SUBJECT: MONTICELLO NUCLEAR GENERATING PLANT – STAFF ASSESSMENT OF
RESPONSE TO 10 CFR 50.54(f) INFORMATION REQUEST – FLOOD-
CAUSING MECHANISM REEVALUATION (CAC NO. MF7712)

STAFF ASSESSMENT BY THE OFFICE OF NUCLEAR REACTOR REGULATION

RELATED TO FLOODING HAZARD REEVALUATION REPORT

MONTICELLO NUCLEAR GENERATING PLANT

Figure 3.2-1. Drainage Sub-Basins (Areas) and Flow Path Directions Applicable to the Monticello LIP Analysis (Xcel Energy, 2016)

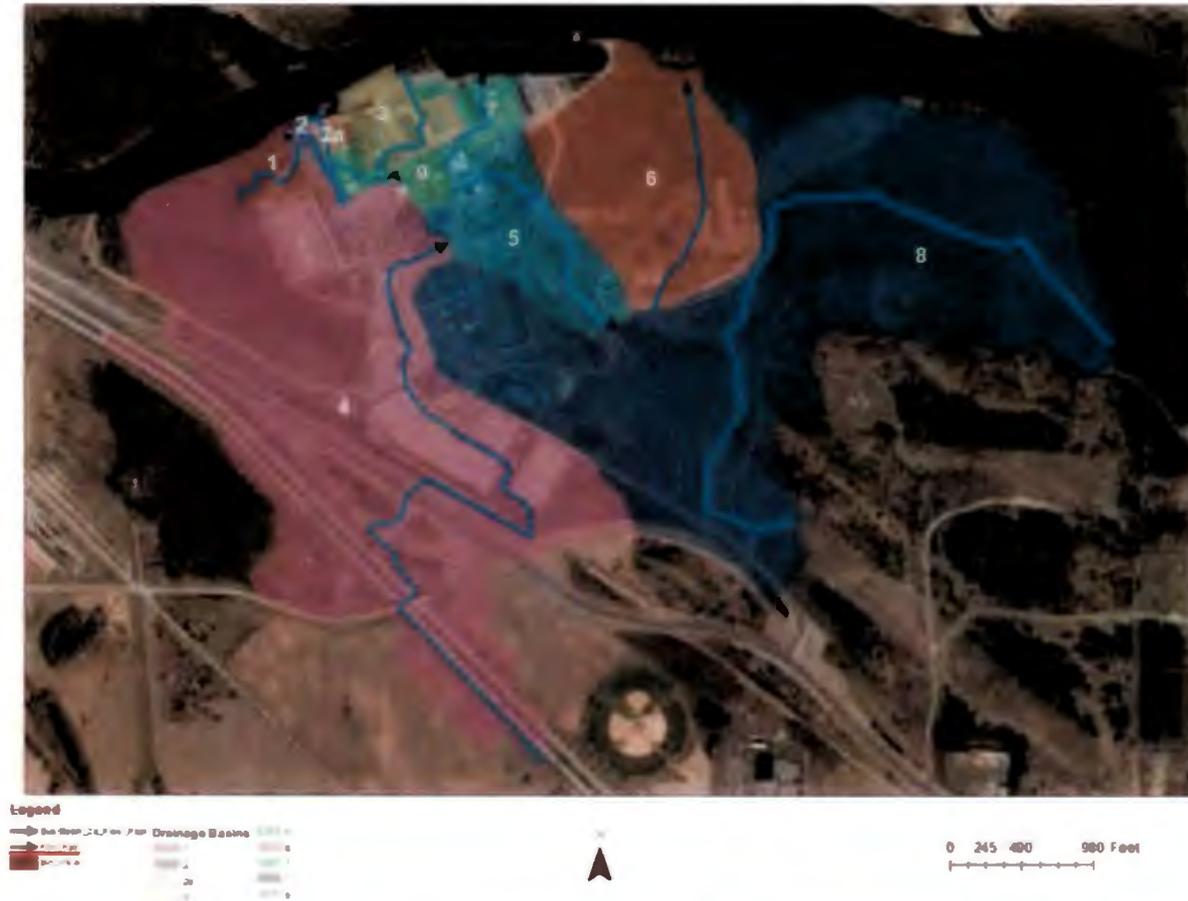
or the complementary LIP flood calculation package (Xcel Energy, 2016). These documents also summarized key details concerning the LIP model. The licensee divided the modeling domain into 10 sub-basins covering the power block area, switchyard, parking lots, and some topographically-higher contributing areas (Figure 3.2-1). The licensee noted that the decisions on how to define the respective sub-basins were based on an examination of ground elevation data obtained from a LiDAR topographic survey, the elevations of various security barriers within the controlled area, and other as-built structures at the site. The licensee noted that the roofs of permanent buildings and other key structures were elevated in the LIP model to ensure that roof drainage would shed onto adjacent ground surfaces in order to maximize flood-related WSE estimates. Elevations of the building footprints inside the study area were increased by at least 10 ft higher than the surrounding land-surface elevation to simulate the taller roof drainage conditions necessary to discharge the rainfall; moreover, those rooftops provided no rainwater storage. As an additional conservatism, site drainage systems were also assumed to be blocked and non-functional allowing for additional rainwater accumulation. Lastly, the licensee stated that the short duration of the precipitation event combined with the high precipitation rate allowed for negligible infiltration by ground surface materials. The NRC staff reviewed the LIP model and found that the basins are appropriately delineated, and the model domain covers the entire reactor site.

Having defined the respective sub-basins, the licensee then used the HEC-HMS software to model overland flow within those domains. The U.S. Soil Conservation Service unit hydrograph method (SCS, 1986) was used to transform the PMP estimate into a probable maximum flow hydrograph for each of the 10 sub-basins; HEC-RAS was then used to model WSEs within the footprint of the powerblock. The licensee created seven hydraulic models using the HEC-RAS software covering the 10 sub-basins simulated in the HEC-HMS model. Four of the hydraulic models were constructed to examine whether flooding from the topographically-higher, off-site areas contiguous with the powerblock would overtop site barriers such as the VBS and, in doing so, increase WSEs within the powerblock. The remaining three HEC-RAS flow models were used to estimate the maximum WSEs at door locations of safety-related structures. As a downstream boundary condition in the HEC-RAS model, the licensee assigned a WSE of 919.5 ft NGVD29 corresponding to a 500-year flood on the Mississippi River for all channel reaches discharging into the river. The NRC staff identified and confirmed the locations of buildings and other structures present within the HEC-RAS modeling domain using available aerial imagery for the Monticello site. Buildings were modeled as obstructions that completely blocked the surface flow of water. The NRC staff also confirmed that the representation of those features with higher elevations would both promote surface flow away from and/or around those locations. Lastly, the NRC staff confirmed that a stage hydrograph elevation proposed as the Mississippi River downstream boundary condition was reasonable.

Figure 3.2-2. All-Season PMP Hyetograph Used in the Monticello LIP Analysis. (Xcel Energy, 2016)

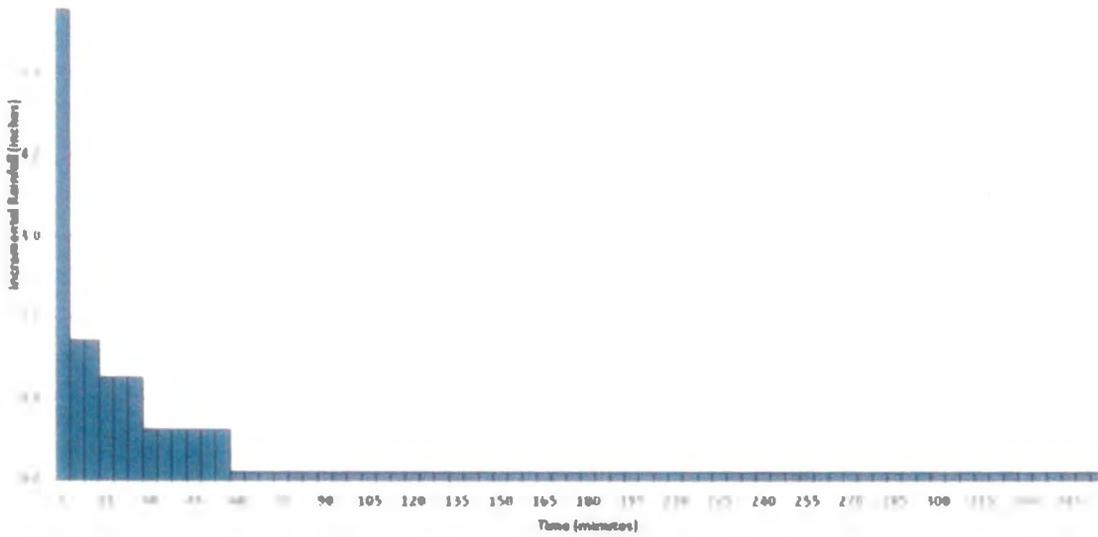
The licensee used the HMR-52 guidance to estimate the 5-minute (min), 15-min, and 30-min precipitation depths on the basis of the 1-h, 1-mi² precipitation intensity. The licensee's PMP depth estimates for all durations using the HMR method are reported in Table 3.2-1; the cumulative precipitation graph is shown in Figure 3.2-2.

The NRC staff reviewed the licensee's approach to the development of the PMP estimate for the LIP model against relevant regulatory criteria based on present-day methodologies and regulatory guidance. In connection with that review, the NRC staff independently estimated the HMR-derived PMP values. As a result of these efforts, the NRC staff concluded that the approach described by the licensee as well as the results are reasonable.

13.8 KV Room (Door 1)

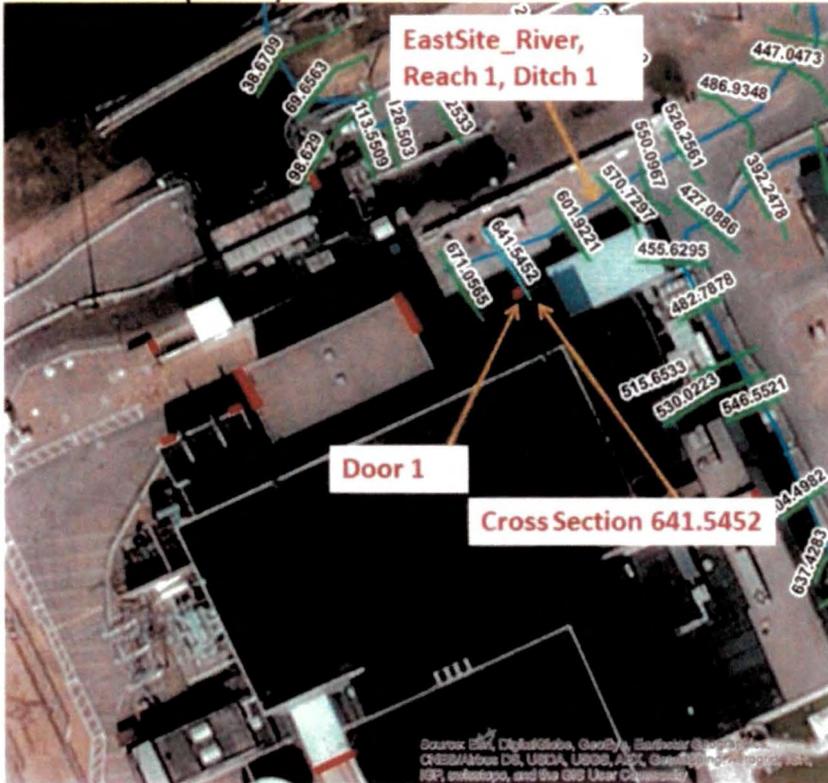
<p>(1) Door locations are depicted in figures found in the appendix. (2) Reported values are rounded to the nearest one-tenth of a foot. (3) The updated values from the licensee (Figure A-1) after the audit and were rounded to 931.5 and 0.5 in Fields's email (Fields, 2016).</p>

Source:
Calculation
180999.51 1005 Rev. 2
Table 5 4-5
Door 1
WSE 933.09 ft NGVD29 -
corrected to 931.49 ft
